## URGENT – Medical Device Correction

### Philips IntelliVue MX40 Patient Wearable Monitor Configuration Setting Disables Generation and Delivery of ECG Alarms to PIIC iX

Figure 1: Device Info screen indicating software revision

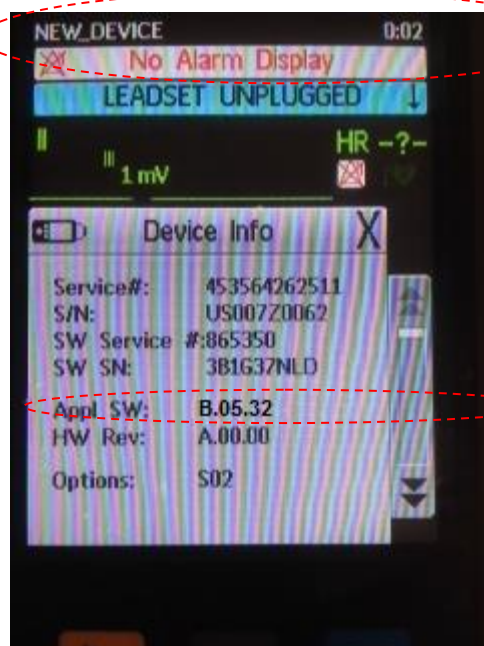
The MX40 software revision is identified by touching the battery icon in the lower right of the MX40 display which opens the Device Status window. In the Device Status window, touch the Device Info text, to display the application software (Appl SW) version:
